POWER DISTRIBUTION LIMITS

3/4.2.3 MINIMUM CRITICAL POWER RATIO

8409120388 840906
PDR ADCK 05000387
P PDR

FIGURE 3.2.3-1a

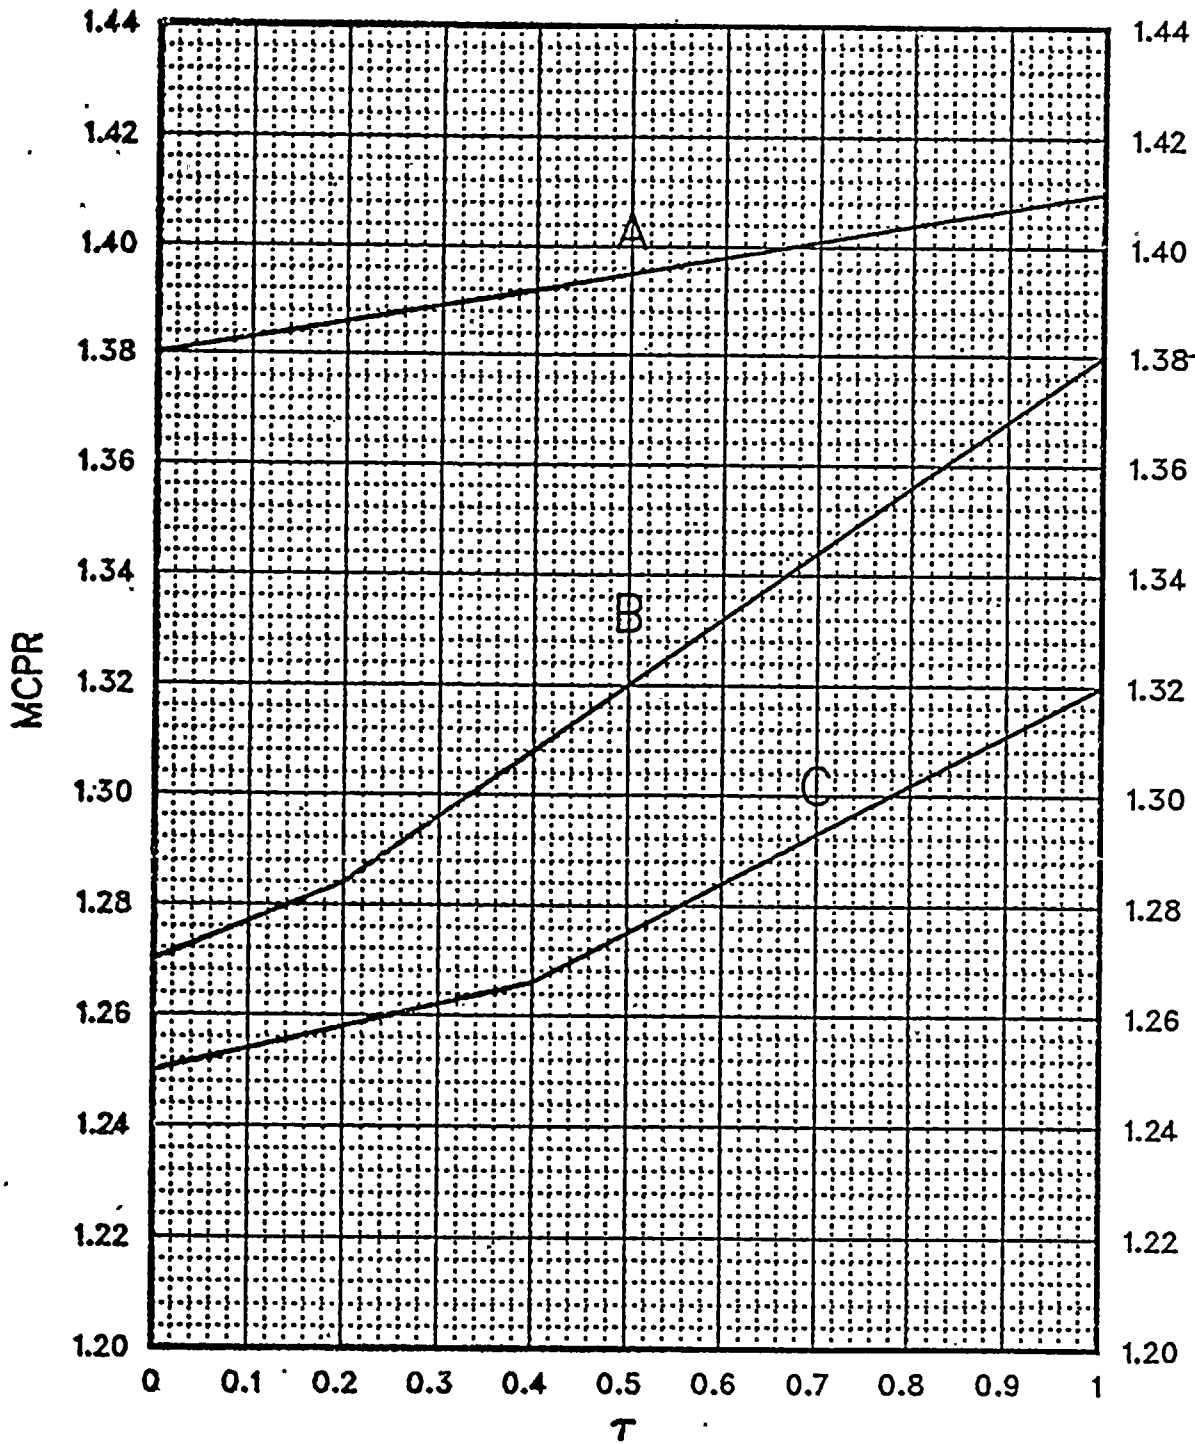
3.2.3 The MINIMUM CRITICAL POWER RATIO (MCPR) shall be equal to or greater than the MCPR limit determined from Figure 3.2.3-1 times the K_x shown in Figure 3.2.3-2, provided that the end-of-cycle recirculation pump trip (EOC-RPT) system is OPERABLE per Specification 3.3.4.2, with:

a or Figure 3.2.3-1b, as applicable,

a or Figure 3.2.3-1b, as applicable, Figure

When the less operationally limiting Rod Block Monitoring trip setpoint ($.66W + 42\%$ from Table 3.3.6-2) is used, the more limiting MCPR curve Figure 3.2.3-1b is applicable due to a larger delta MCPR from the limiting Rod Withdrawal Error (RWE) transient. Figure 3.2.3-1a is applicable when the Rod Block Monitor trip setpoint ($.66W + 40\%$ from Table 3.3.6-2) is used.

FIGURE 3.2.3-1a

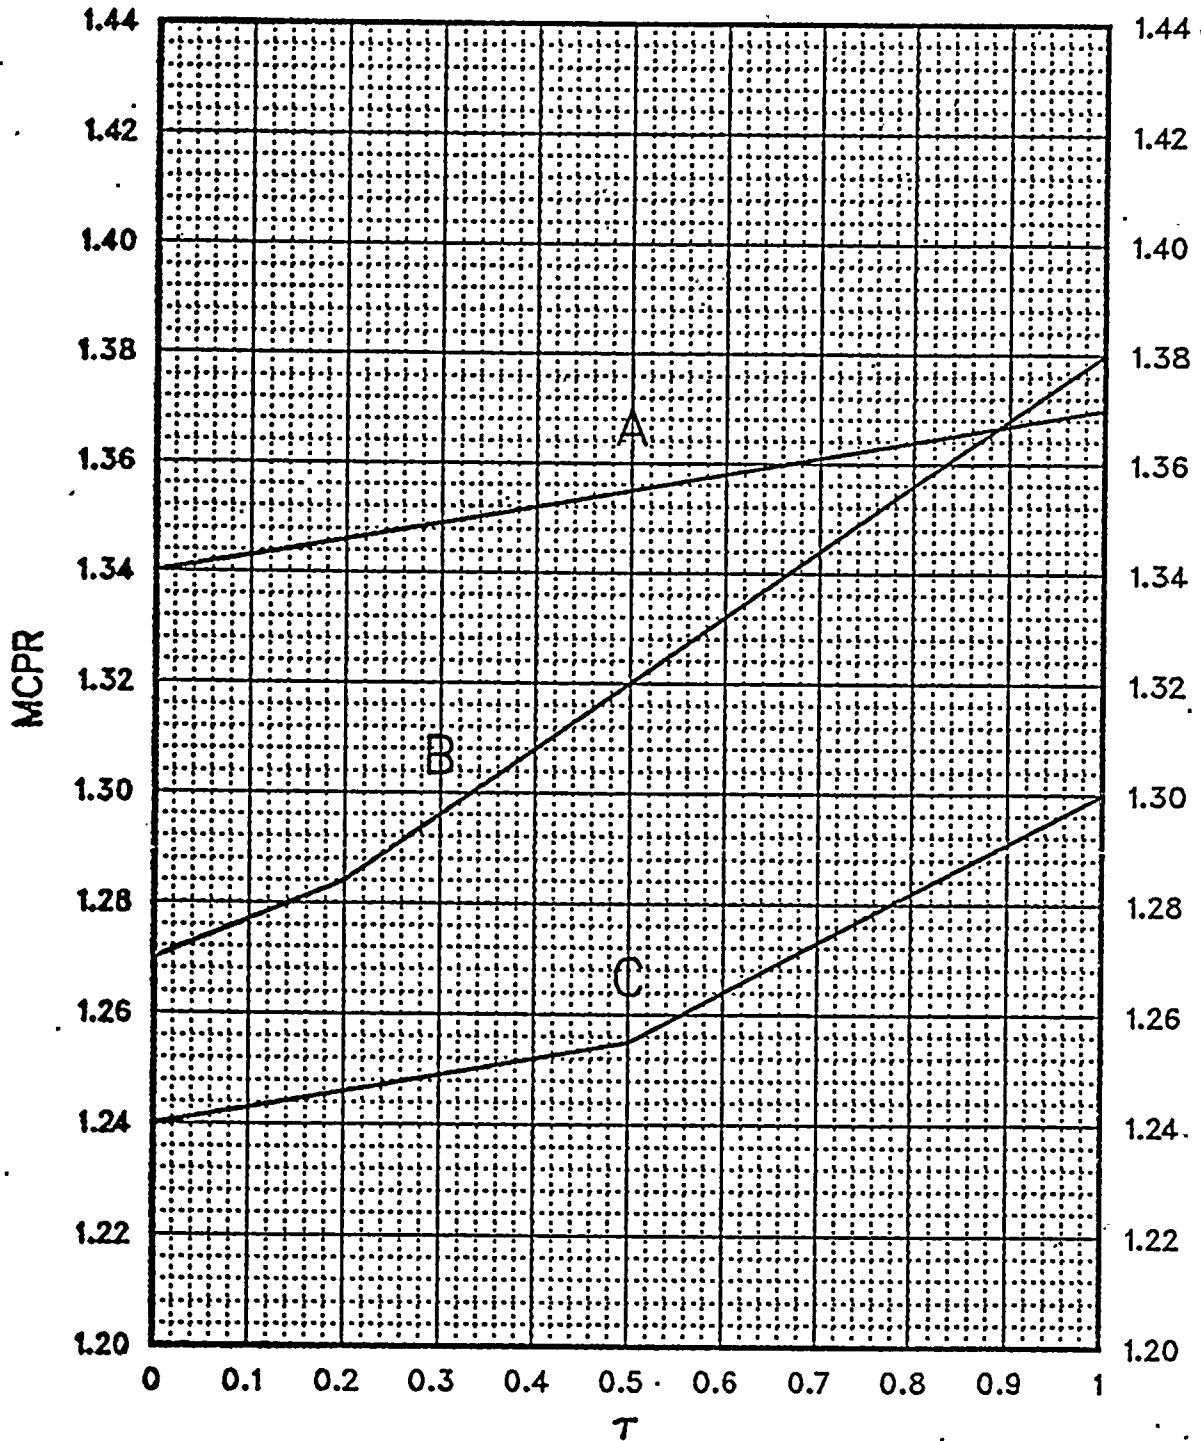
3.2.3 The MINIMUM CRITICAL POWER RATIO (MCPR) shall be equal to or greater than the MCPR limit determined from Figure 3.2.3-1, times the K_f shown in Figure 3.2.3-2, provided that the end-of-cycle recirculation pump trip (EOC-RPT) system is OPERABLE per Specification 3.3.4.2 and the turbine bypass system is OPERABLE per Specification 3.7.8, with:

a or Figure 3.2.3-1 b, as applicable,

a or Figure 3.2.3-1 b, as applicable, Figure

When the less operationally limiting Rod Block Monitoring trip setpoint ($.66W + 42\%$ from Table 3.3.6-2) is used, the more limiting MCPR curve Figure 3.2.3-1b is applicable due to a larger delta MCPR from the limiting Rod Withdrawal Error (RWE) transient. Figure 3.2.3-1a is applicable when the Rod Block Monitor trip setpoint ($.66W + 40\%$ from Table 3.3.6-2) is used.
